RHODE ISLAND DEPARTMENT OF TRANSPORTATION

RHODE ISLAND CONTRACT NO.2014-CH-028

Apponaug Circulator By-Pass

ADDENDUM NO. 2 Prospective bidders and all concerned are hereby notified of the following changes in the Plans, Specifications, Proposal and Distribution of Quantities for this contract. These changes shall be incorporated in the Plans, Specifications, Proposal and Distribution of Quantities, and shall become an integral part of the Contract Documents.

Gordon R. Archibald, Inc. Civil and Environmental Engineers Pawtucket, Rhode Island	TITLE OF SKETCH APPONAUG CIRCULATOR LONGTERM IMPROVEMENTS	R.I. CONTRACT NO. 2014-CH-028
	JOB SPECIFIC PLAN SYMBOLS, LEGEND & NOTES	SKETCH NO. 1
DATE: 4/1/2014	ADDENDUM NUMBER 2	REVISION TO VOL. 1 OF 4 SHEET NO. 5

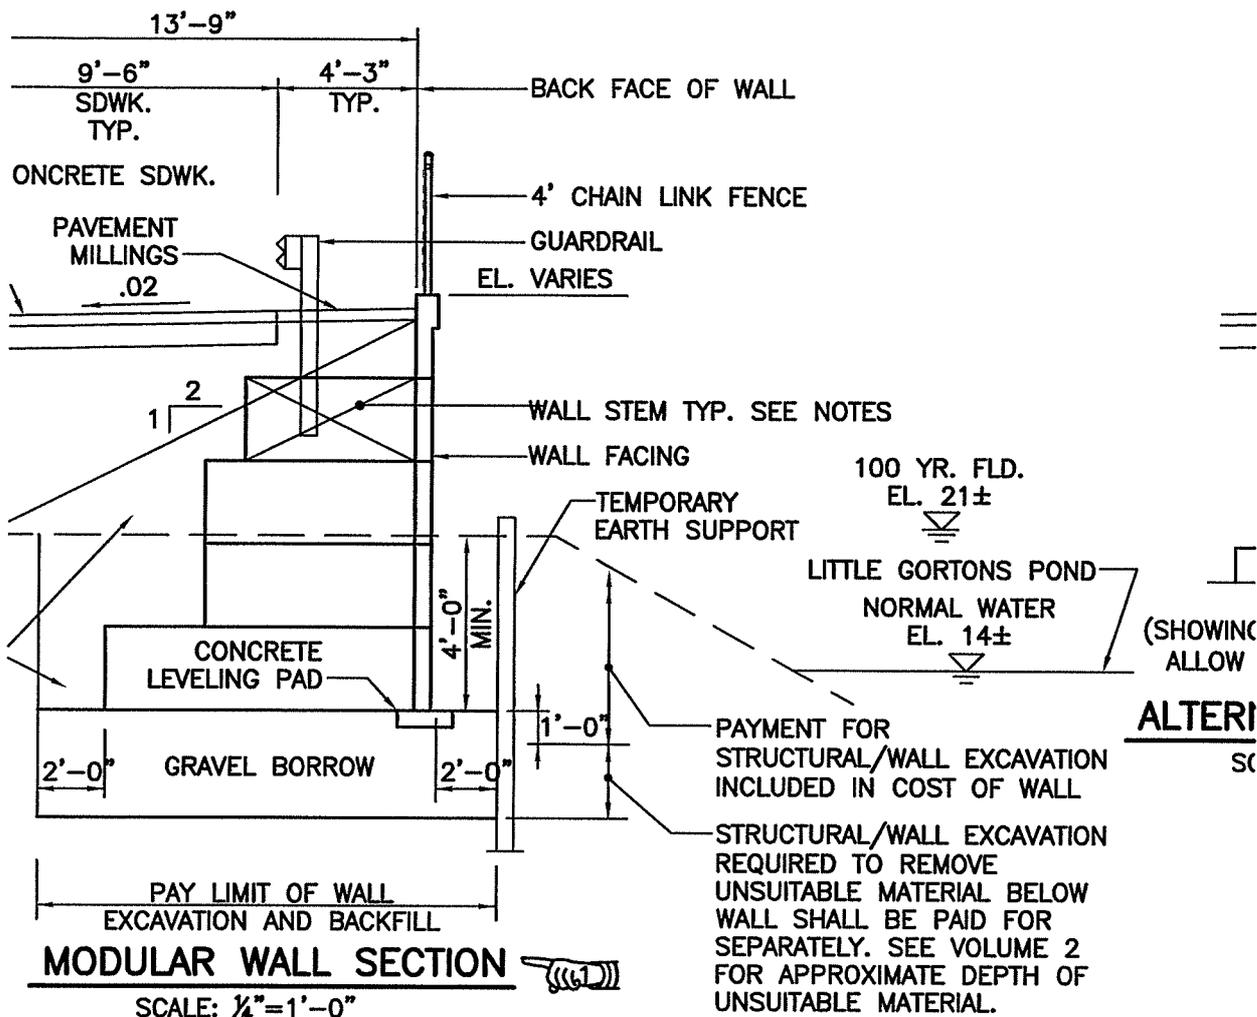
1. Volume 1 of 4 – Sheet No. 5 – Job Specific Plan Symbols, Legend & Notes

Revise Sheet No. 5 as shown on Sketch No. 1(R-1) attached to this Addendum No. 2. Job Specific Legend description for BCD1 has been revised and Job Specific General Note No. 6 has been revised.

Gordon R. Archibald, Inc. Civil and Environmental Engineers Pawtucket, Rhode Island	TITLE OF SKETCH APPONAUG CIRCULATOR LONGTERM IMPROVEMENTS	R.I. CONTRACT NO. 2014-CH-028
	LITTLE GORTONS POND (LGP) WALL DETAILS-2	SKETCH NO. 2
DATE: 4/8/2014	ADDENDUM NUMBER 2	REVISION TO VOL. 1 OF 4 SHEET NO. 32

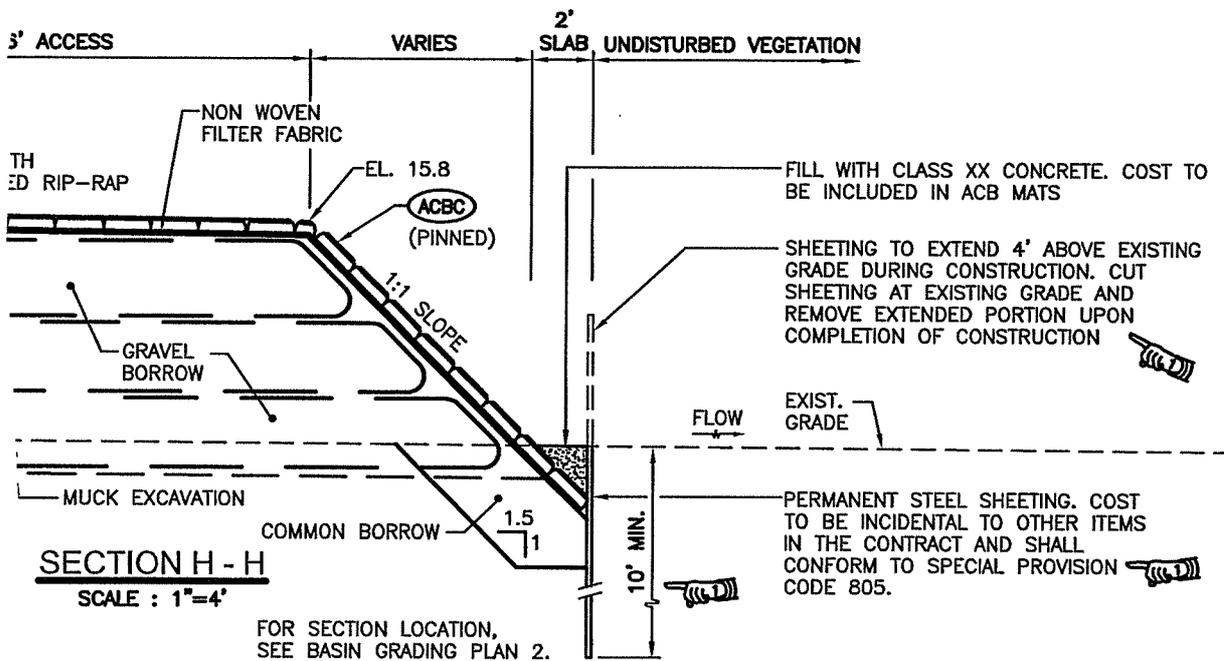
2. Volume 1 of 4 – Sheet No. 32 – Wall Details-2

Revise Sheet No. 32 as shown on Sketch No. 2(R-1) attached to this Addendum No. 2. The limits of Structural Excavation have been clarified.

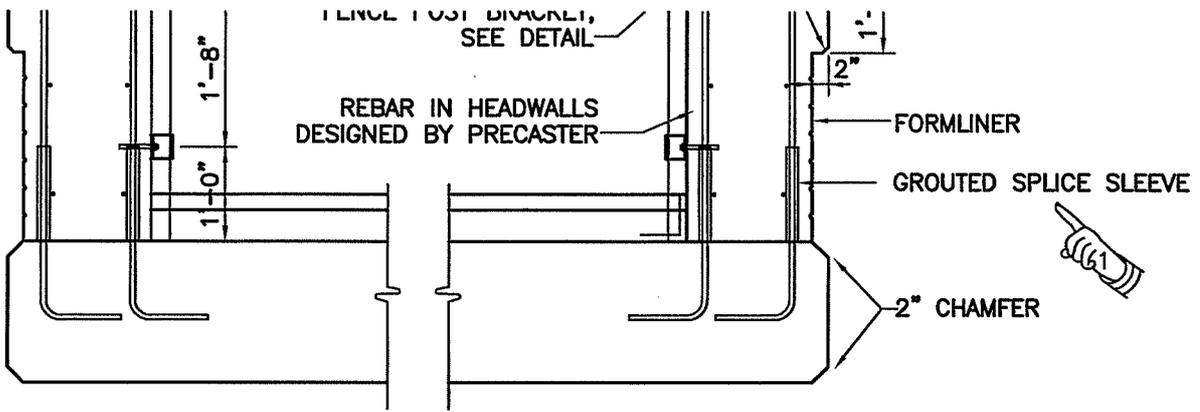
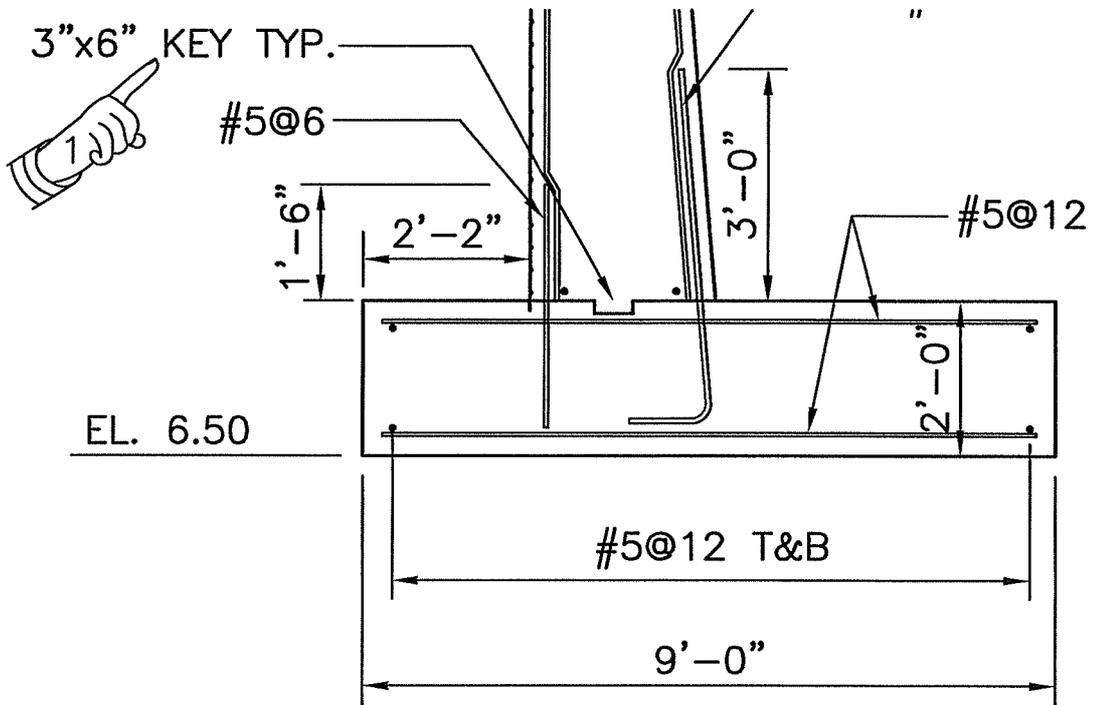
3. Volume 1 of 4 – Sheet No. 75 – Drainage Details-5

Revise Sheet No. 75 as shown on Sketch No. 3(R-1) attached to this Addendum No. 2. The sheeting callouts and dimensions have been revised.

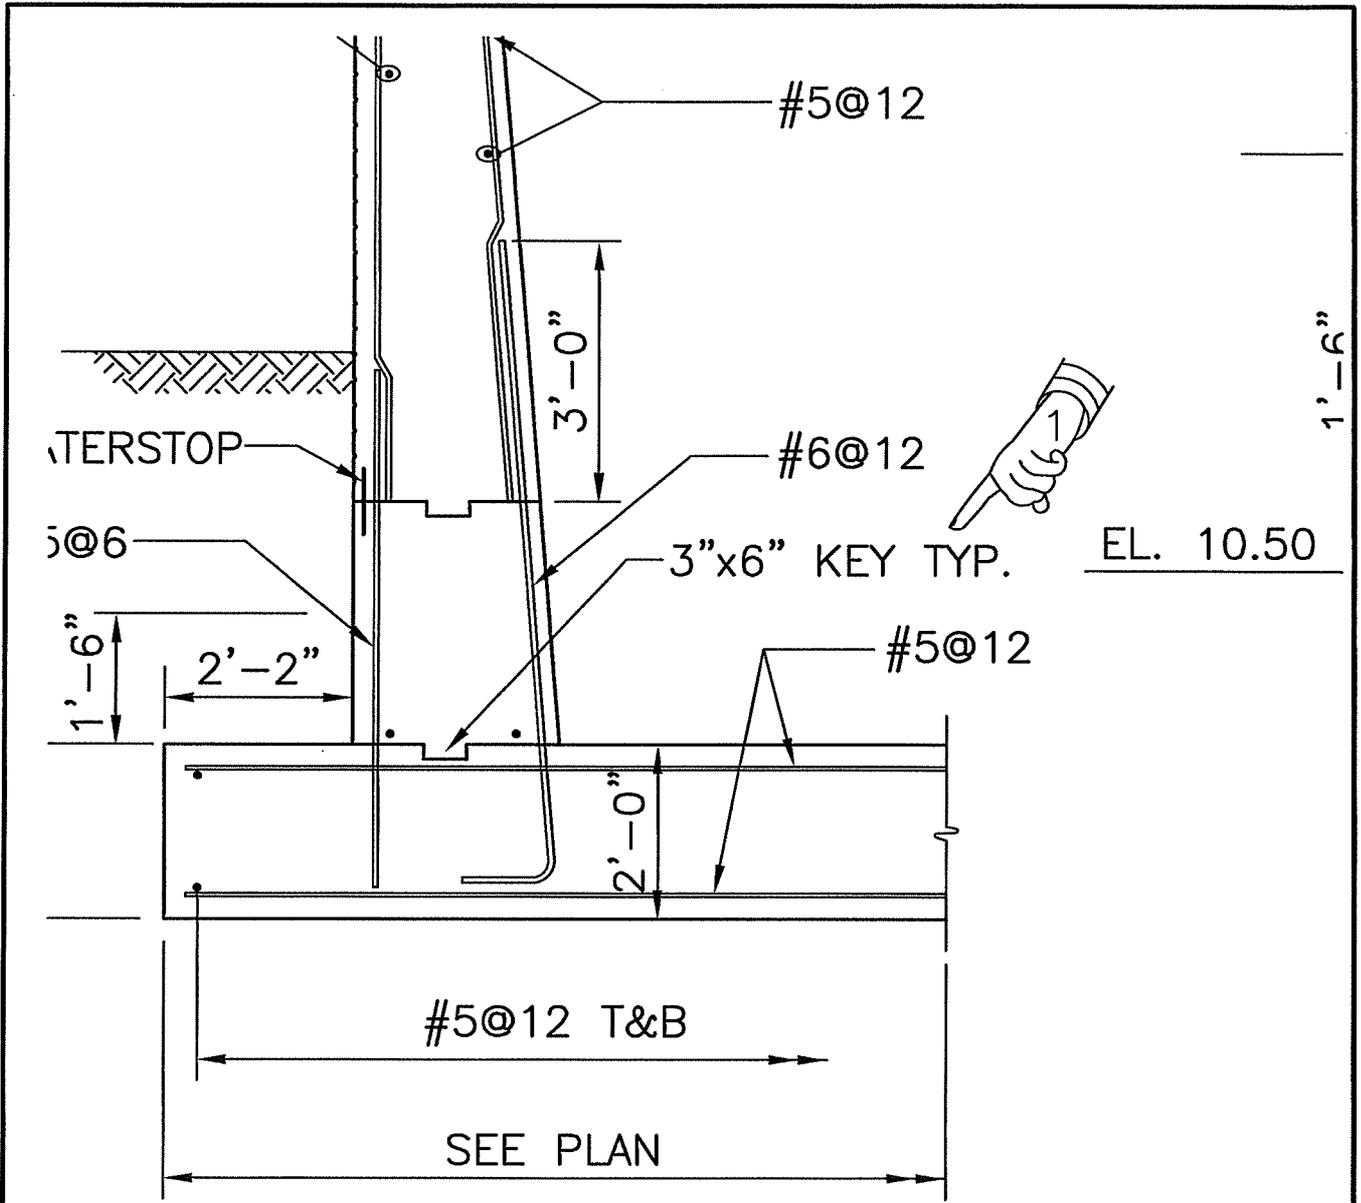
4. Volume 1 of 4 – Sheet No. 79 – Drainage Details-9

Revise Sheet No. 79 as shown on Sketch No. 4(R-1) attached to this Addendum No. 2. The callout for the Grouted Splice Sleeve has been revised and the Footing Key dimensions have been added.

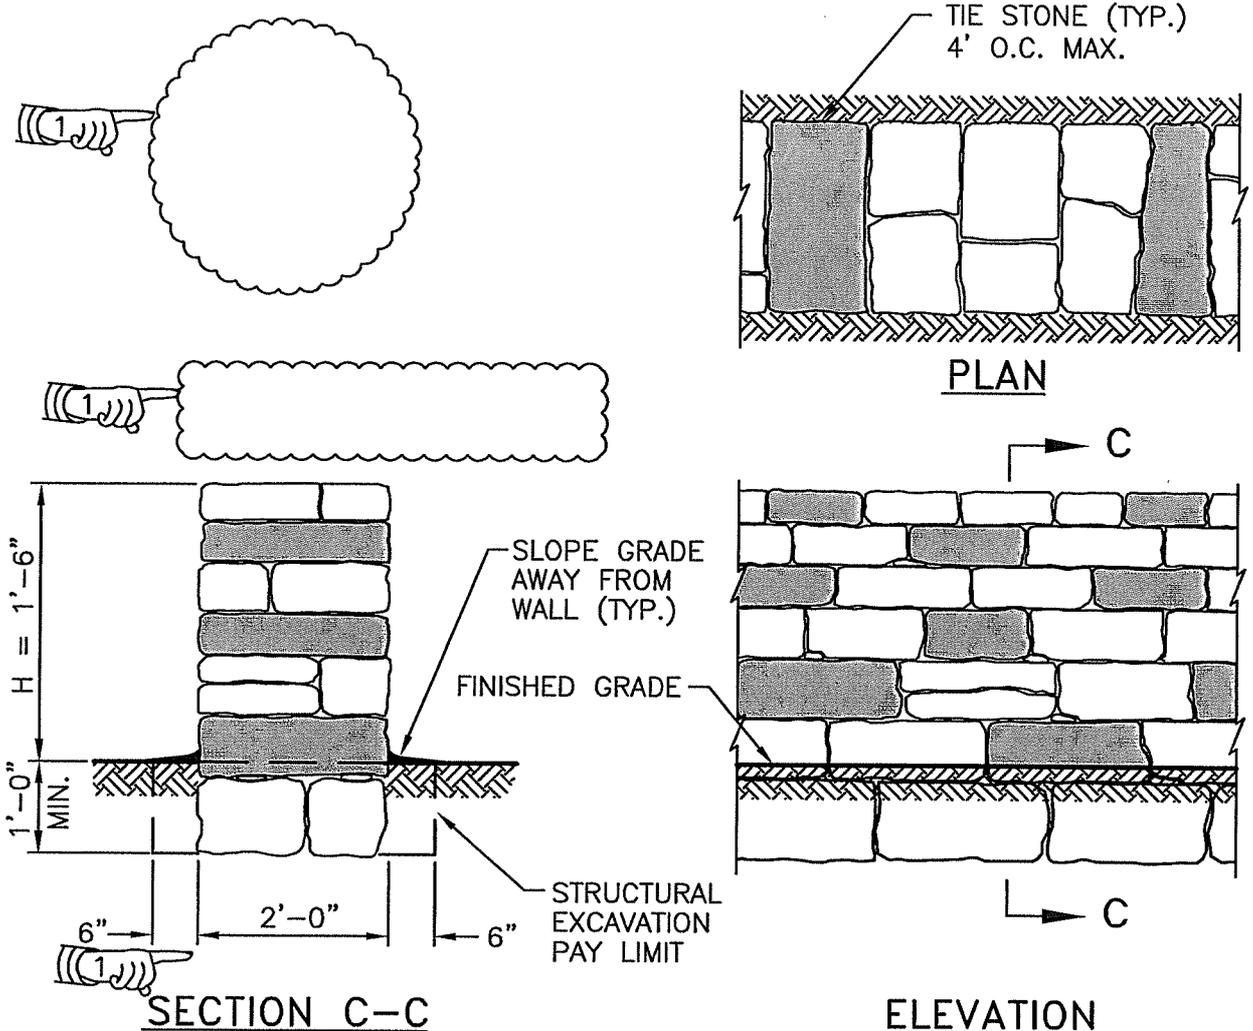
5. Volume 1 of 4 – Sheet No. 81 – Drainage Details-11

Revise Sheet No. 81 as shown on Sketch No. 5(R-1) attached to this Addendum No. 2. The Footing Key dimensions have been added.

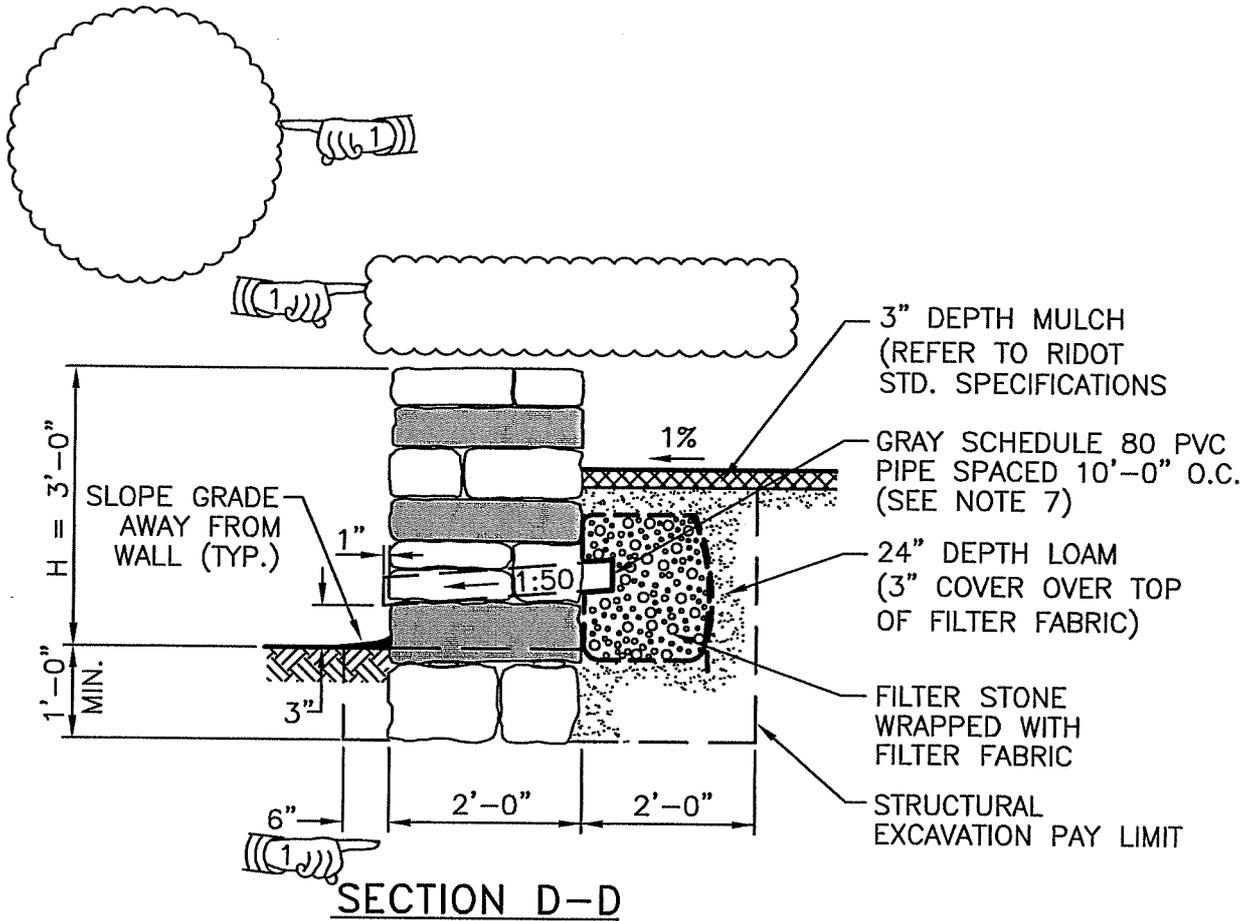
6. Volume 1 of 4 – Sheet No. 190 – Landscape Details-1

Revise Sheet No. 190 as shown on Sketch No. 6(R-1) attached to this Addendum No. 2. Recessed joints have been eliminated, and Notes 1, 3, & 5 have been revised on RI Standard 10.2.0 MA.

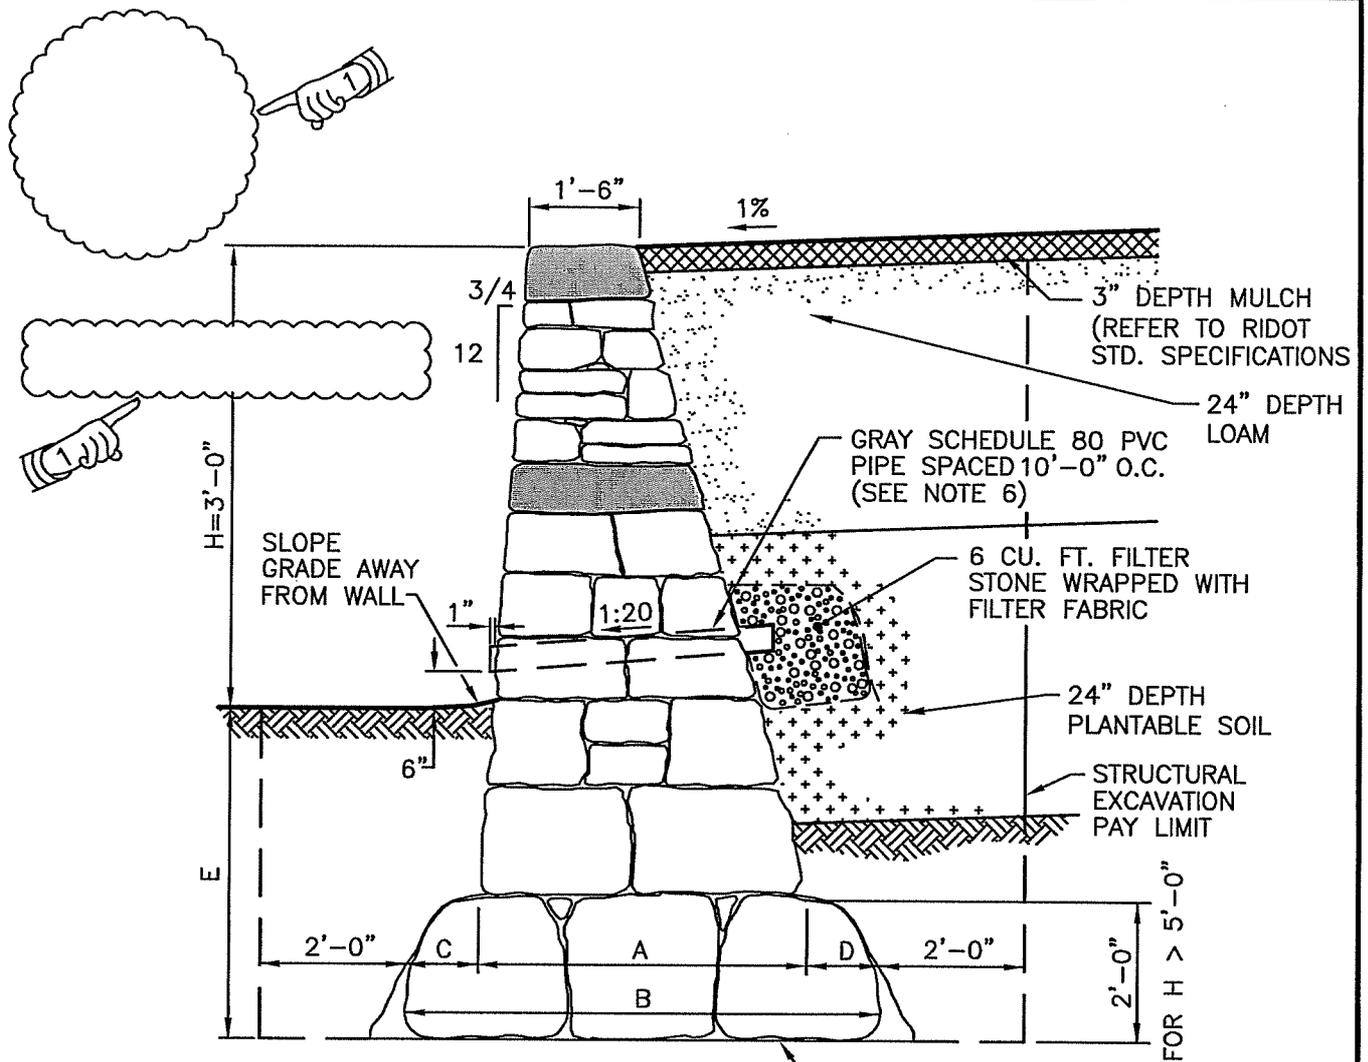
7. Volume 1 of 4 - Sheet No. 190-Landscape Details-1
Revise Sheet No. 190 as shown on Sketch No. 7(R-1) attached to this Addendum No. 2. Recessed joints have been eliminated. Section D-D, and Notes 1,3, & 5 of RI Standard 10.2.0 MB have been revised.

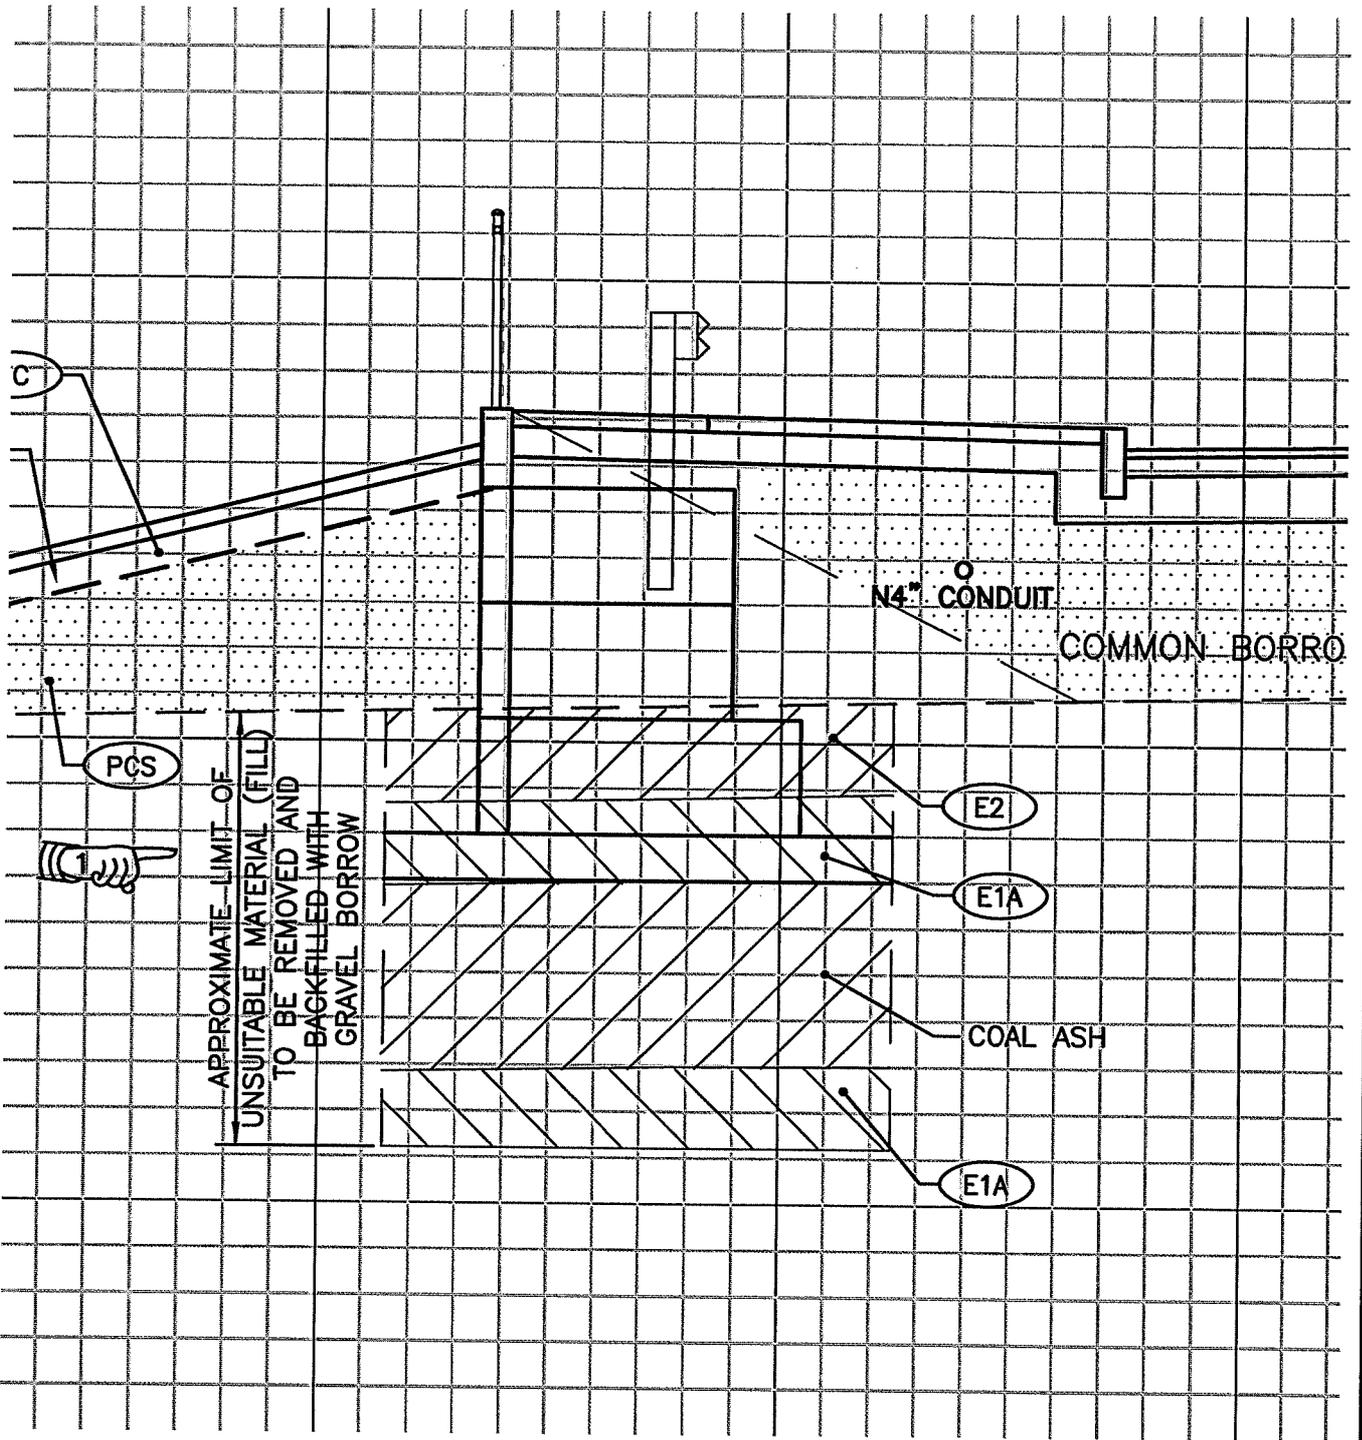
8. Volume 1 of 4 - Sheet No. 190 - Landscape Details-1
Revise Sheet No. 190 as shown on Sketch No. 8(R-1) attached to this Addendum No. 2. Recessed joints have been eliminated and notes 1 & 3 of RI Standard 10.1.0 M have been revised.
